ADDENDUM NO. 03

**Westfield Washington School Corporation
Westfield Middle School West (Site Package)
17707 Centennial Road,
Westfield, IN. 46074**

PROJECT: Westfield Middle School – West (Site Package)

DATE: June 24, 2024

DRAWING NUMBER: C500. PROJECT NUMBER: 2023061.

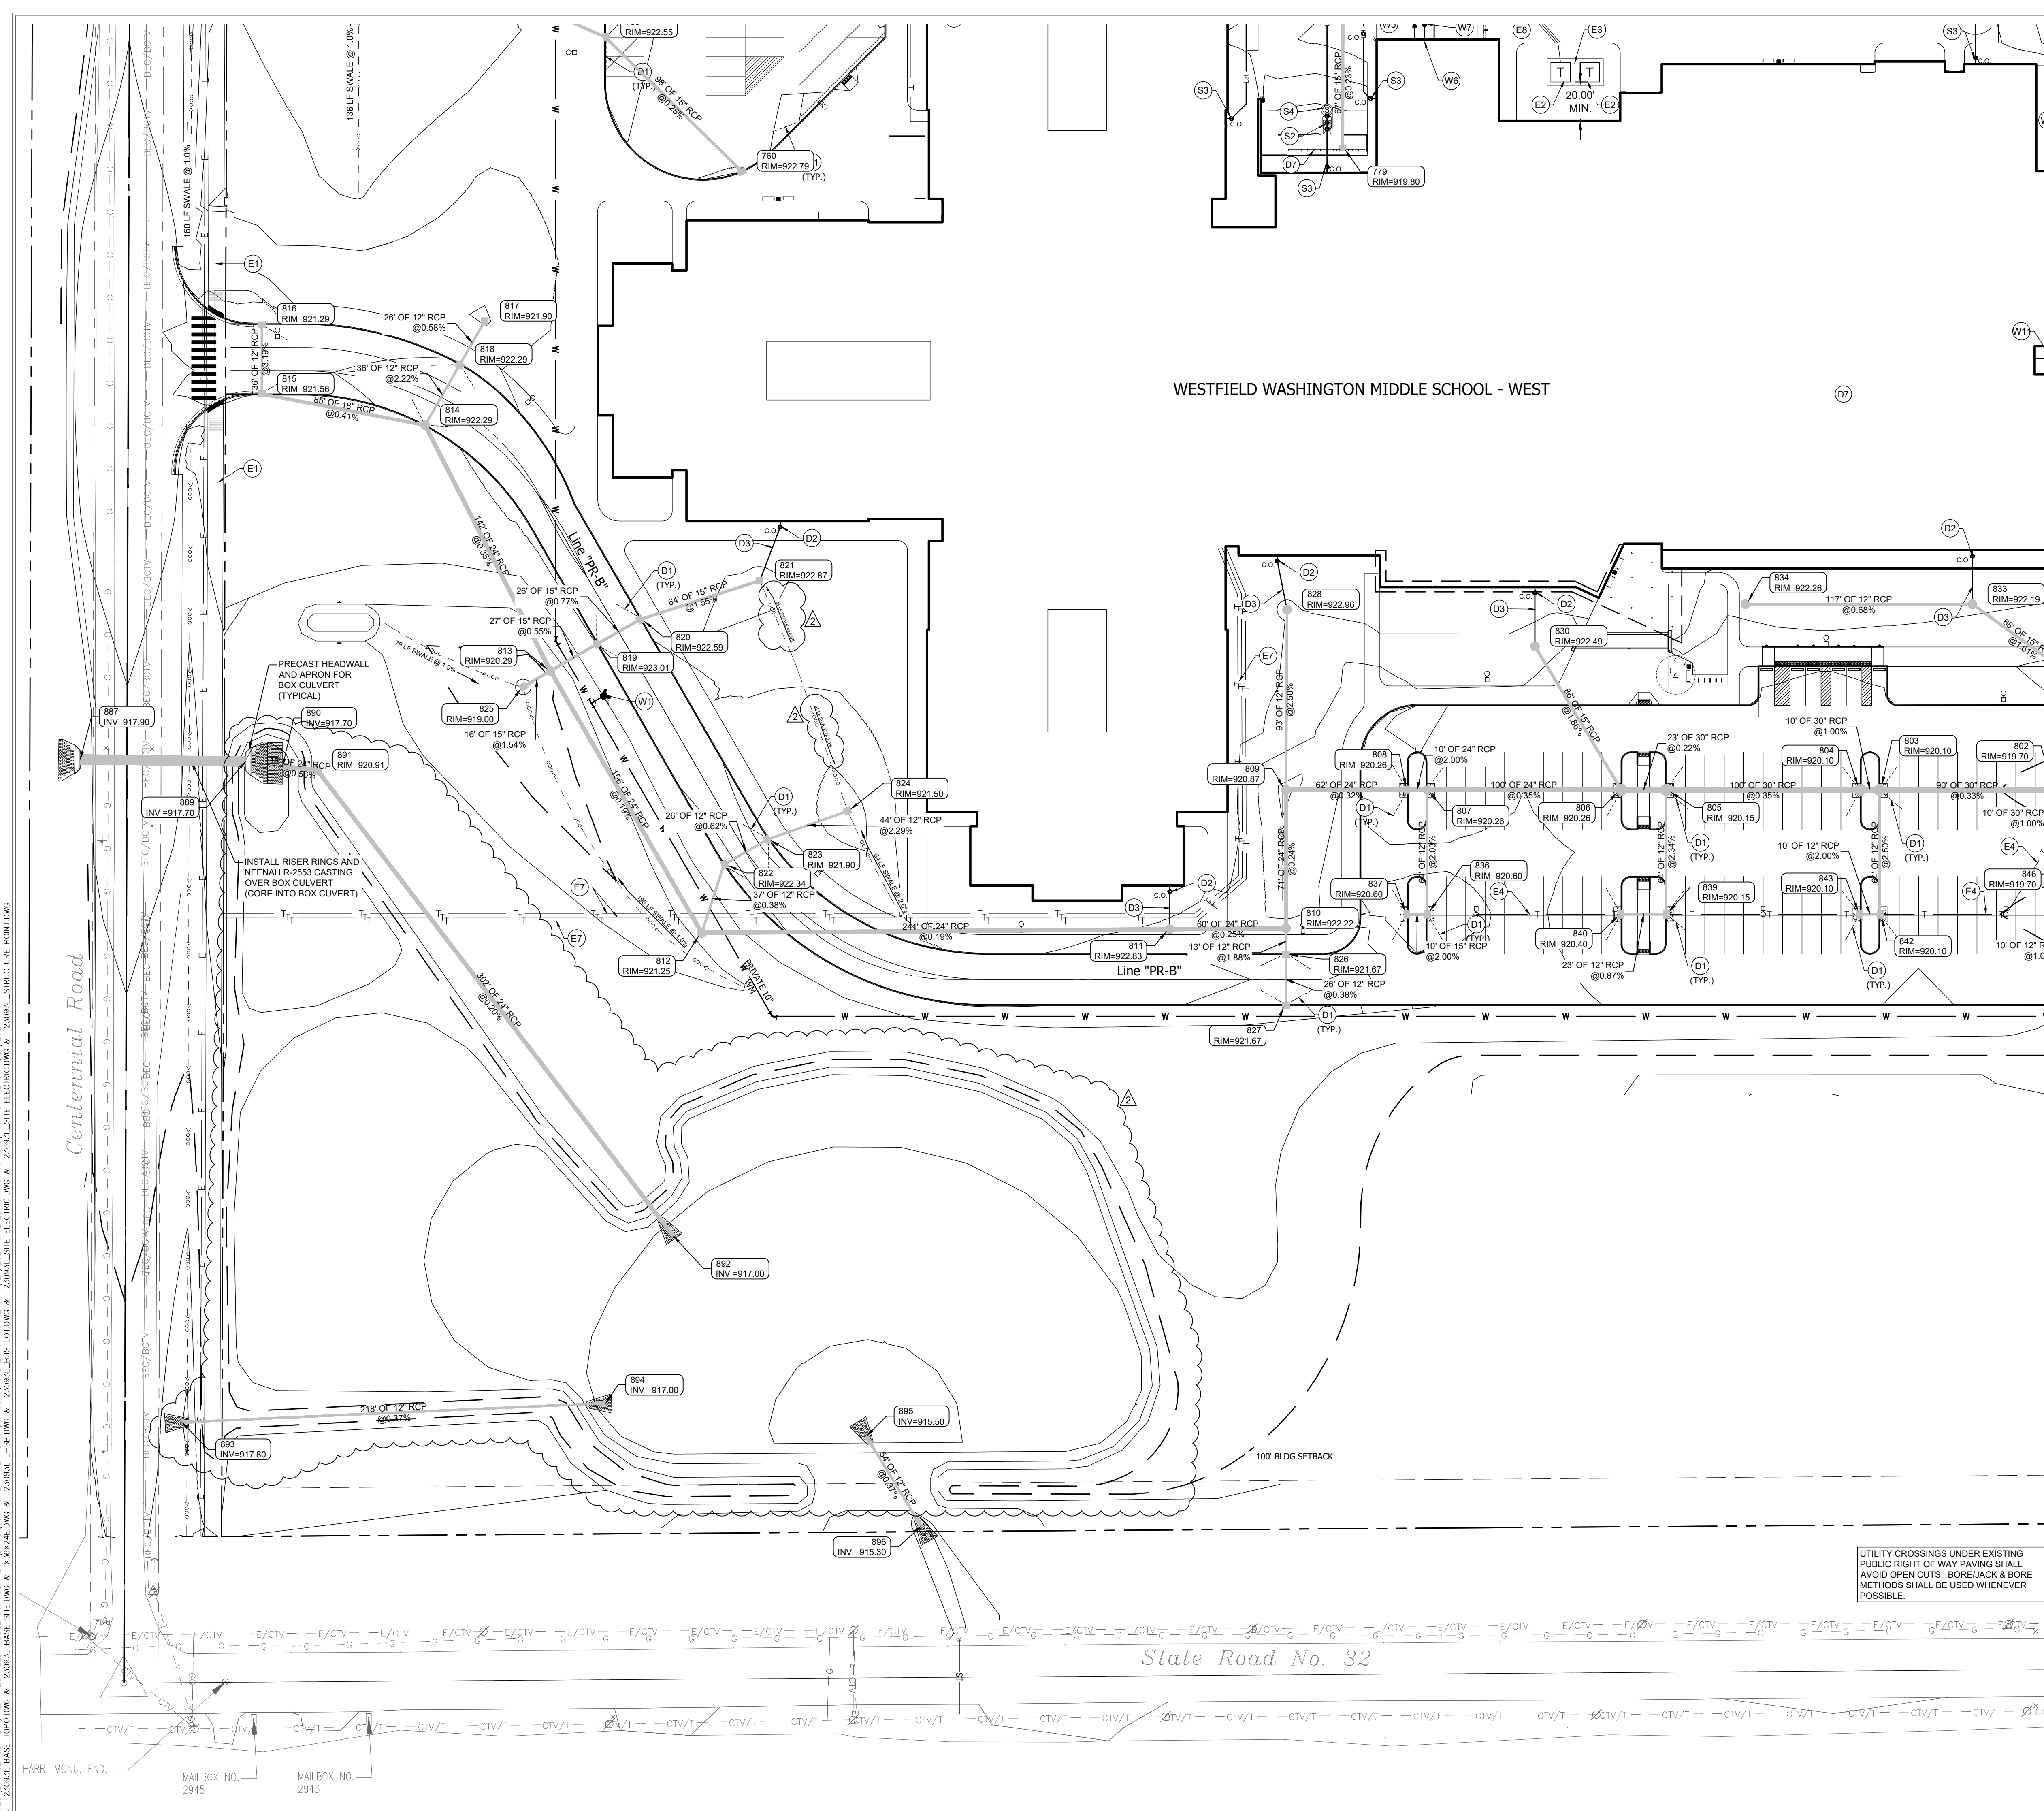
3.1 C100 – COVER SHEET

- A. Added C500 Structure Data Table to the Sheet index
- B. Changed C700 from Overall Storm Plan to Overall Utility Plan
- C. Added Boundary notes from survey

DRAWING NUMBER:
C700
PROJECT NUMBER:
2023061

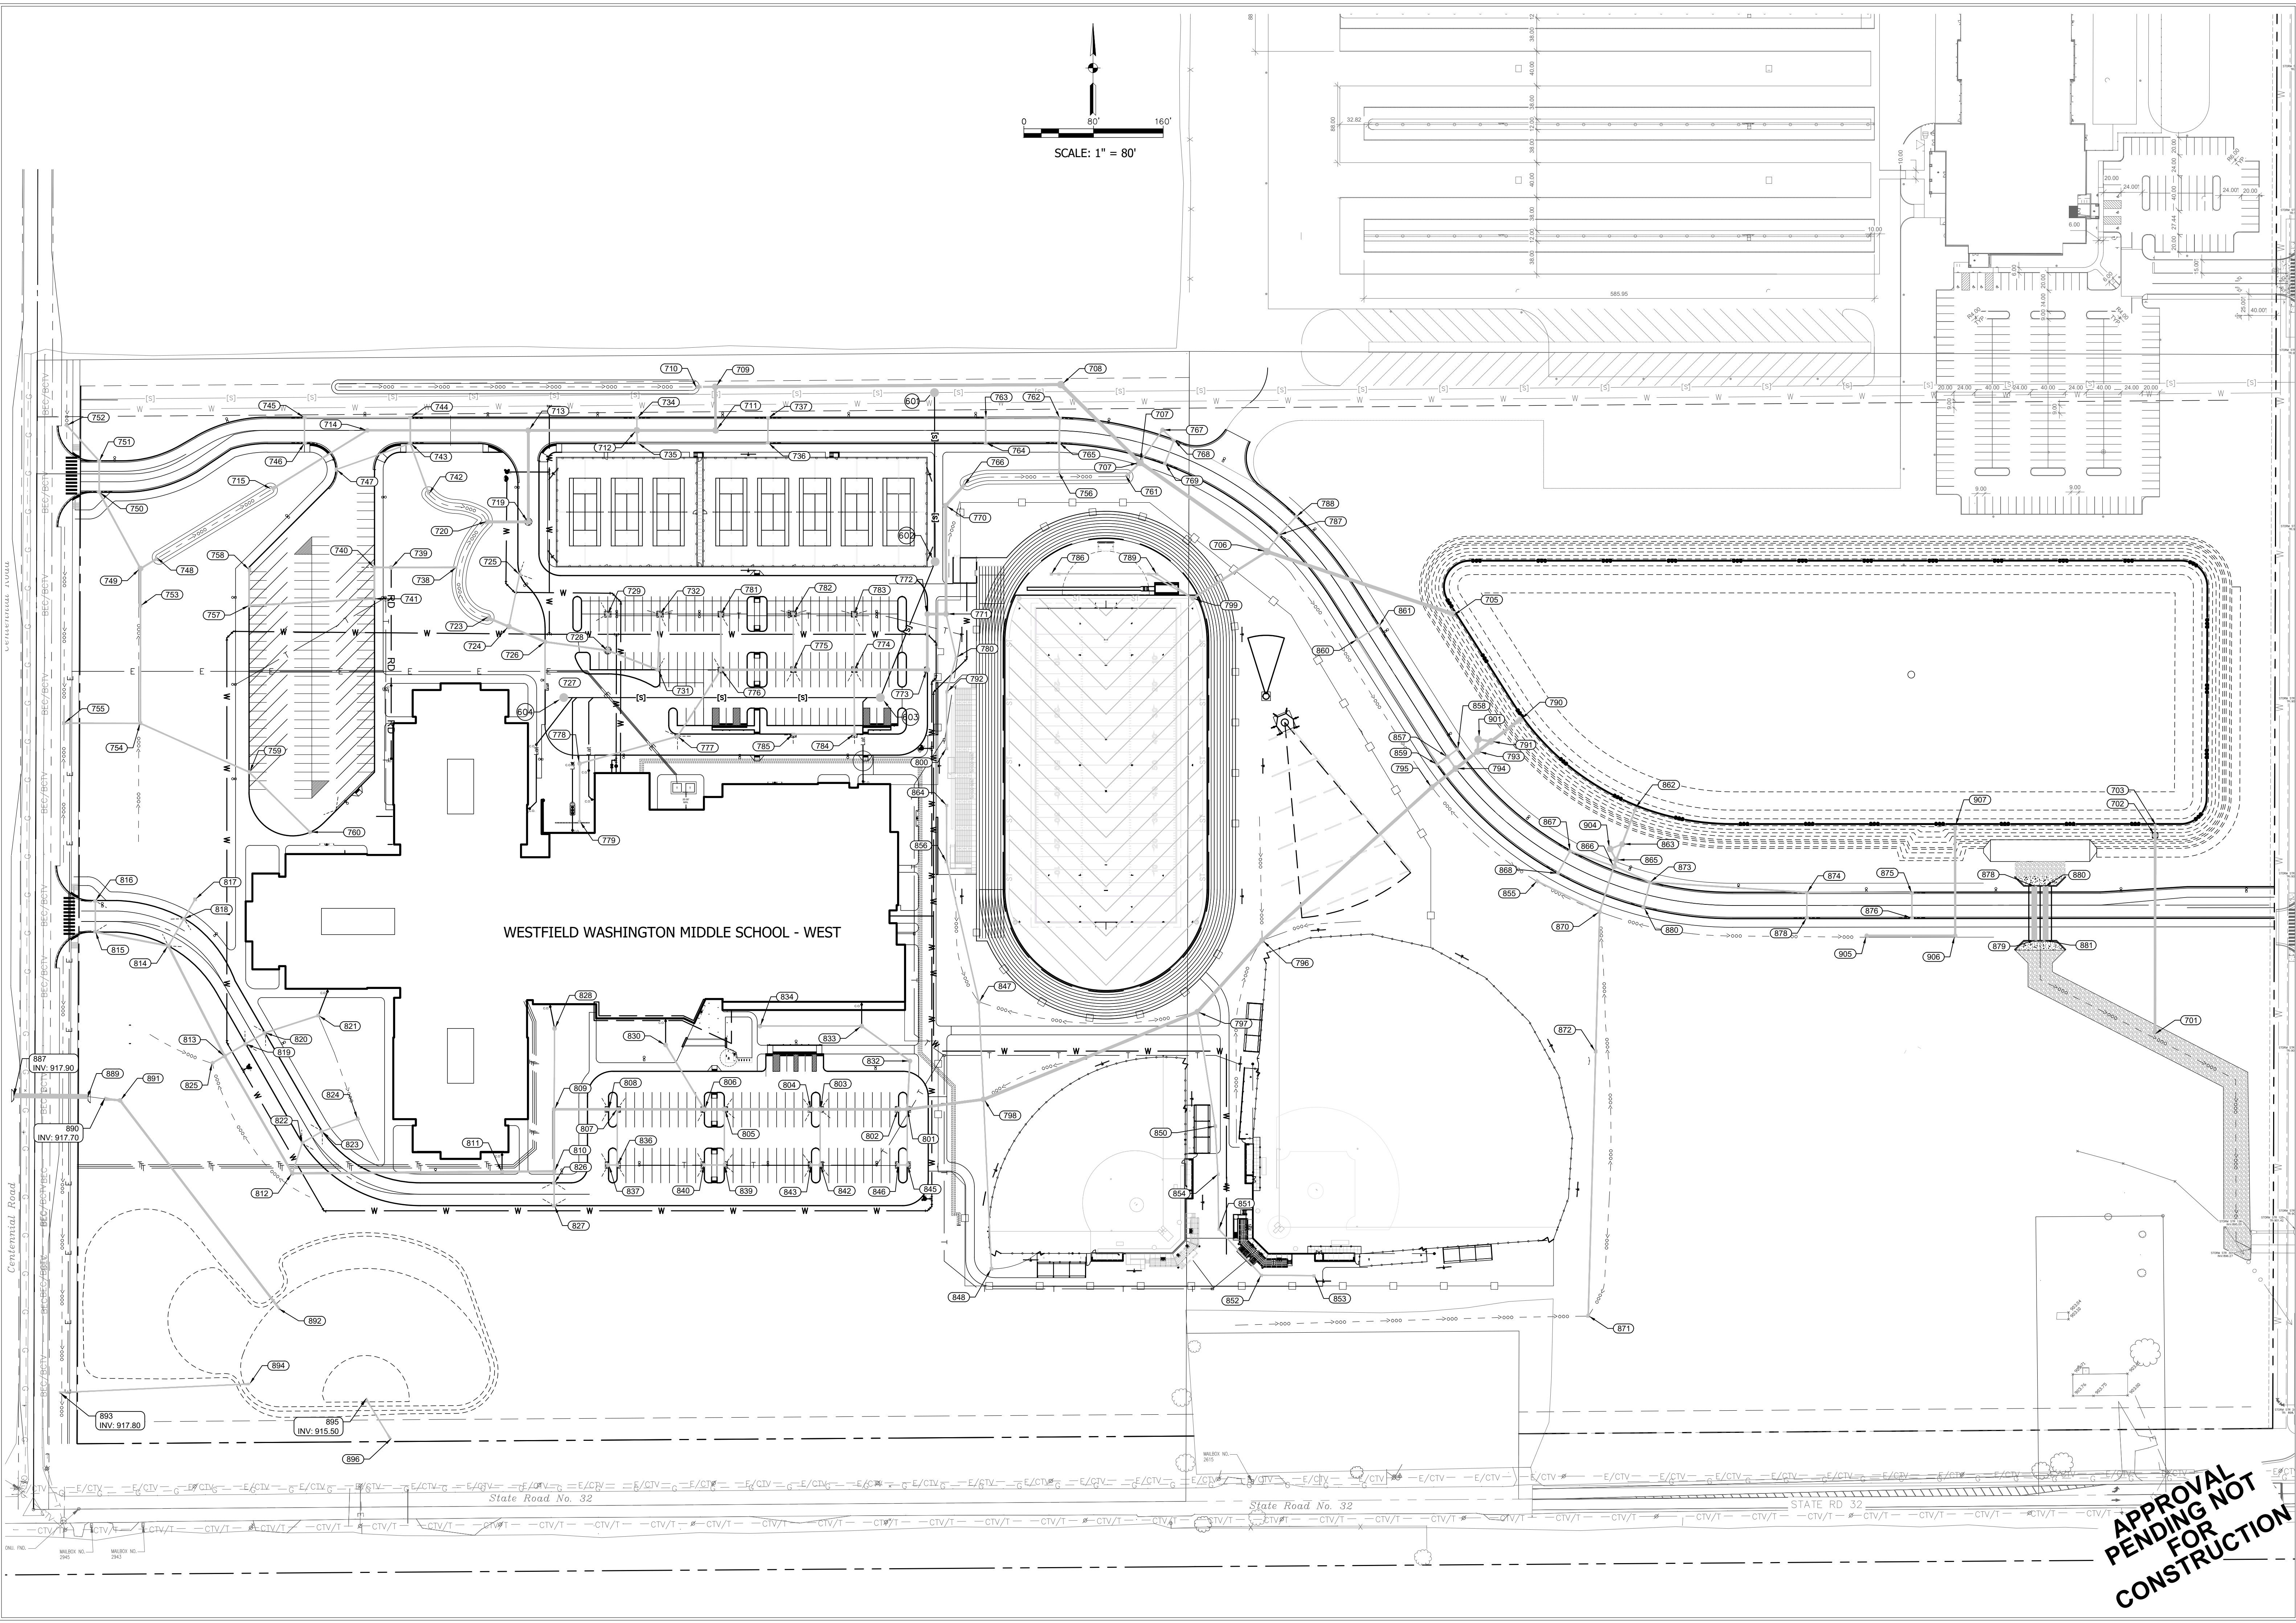
3.23 C700 OVERALL UTILITY PLAN

- A. Added new sheet

4 SW DRY DETENTION SECONDARY OUTLET & EMERGENCY SPILLWAY WEIR
SCALE: NONE

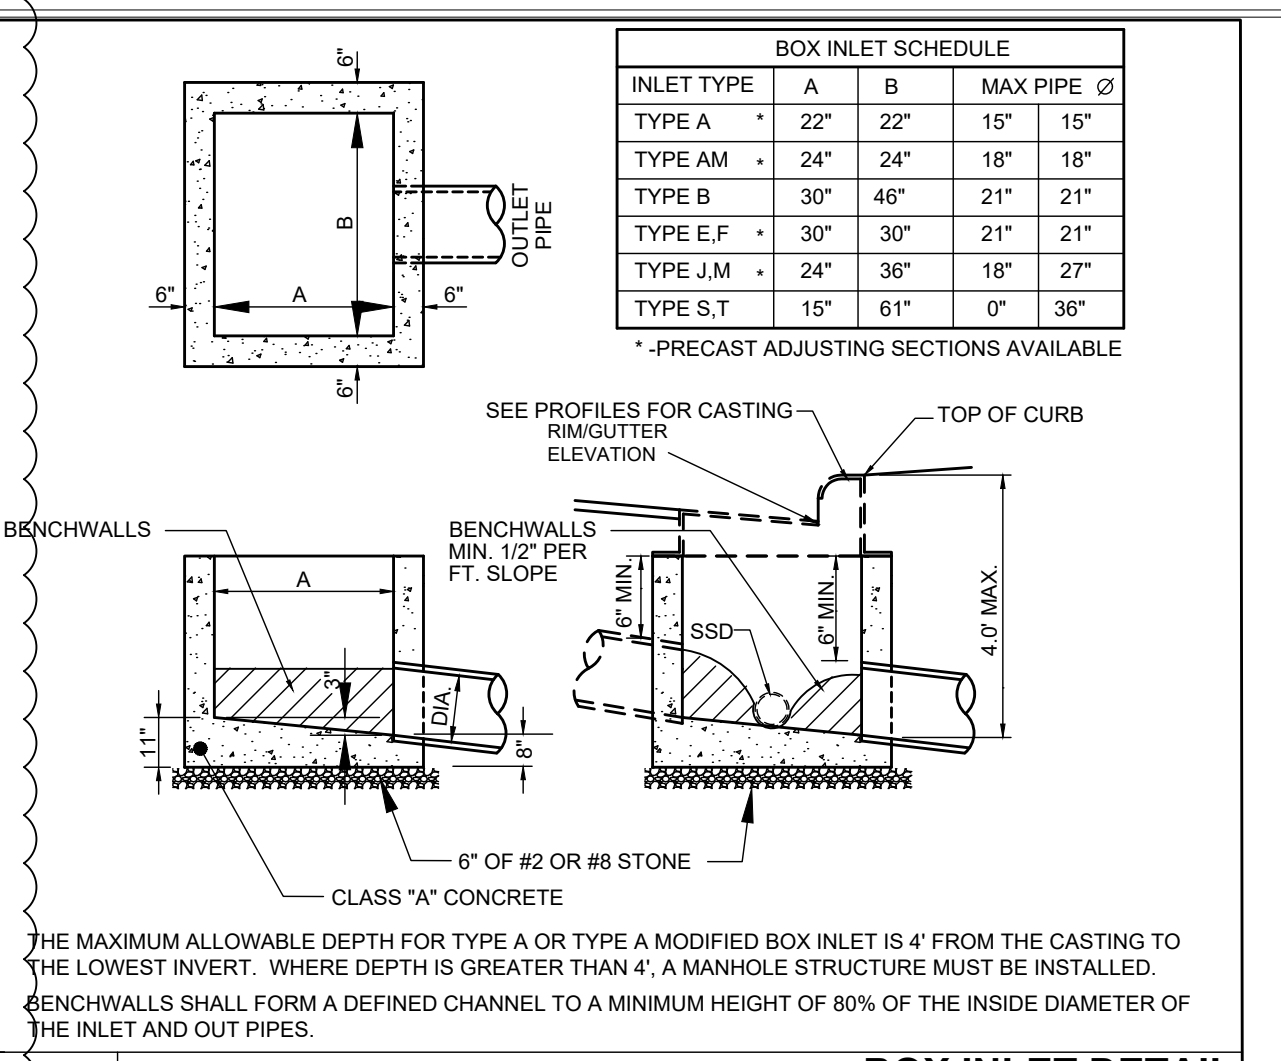
- A. Changed rotation on 4" pvc pipes on trench drain detail (detail #11)
- B. Revised 6" water main to 6" sanitary lateral on trench drain detail (detail #11)
- C. Changed / revised detail 4 – SW Detention Spillway Elevations

11 SUBSURFACE DRAIN DETAIL
SCALE: NONE

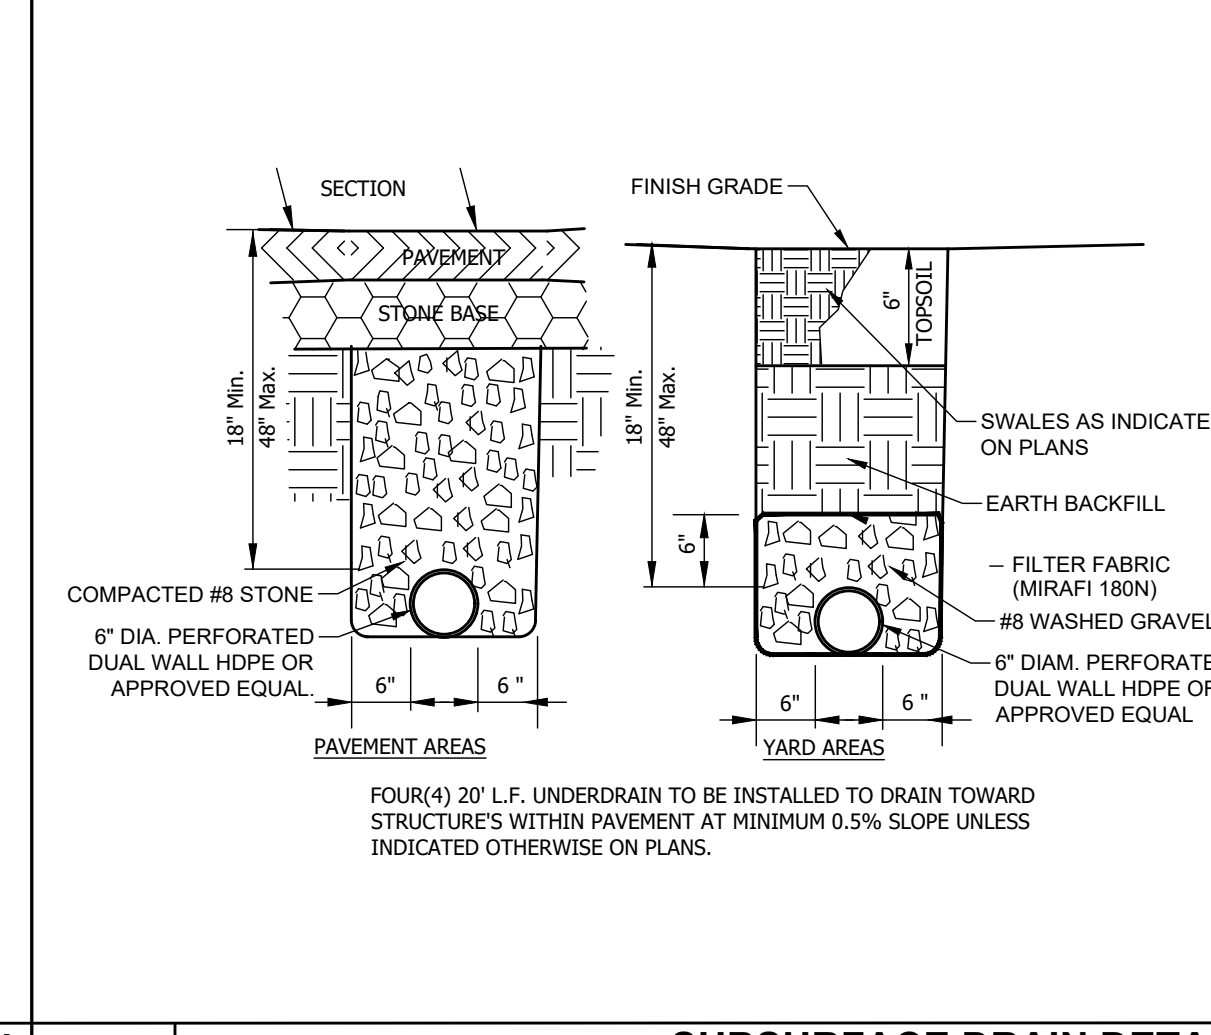
05.31.2024	12	trench drain detail on C901	can you give this detail a number and can you label it maybe as say D5 on C501 thru C505 and clearly show it with a label on C502 and C704 for the loading dock trench drain, also is the 6" water line really passing under it like the detail on C901 shows?	Mike Holtkamp	The utility that is crossing is a sanitary lateral. Keynotes and details have been adjusted.	Karen C	Karen	#02 & #03	Done
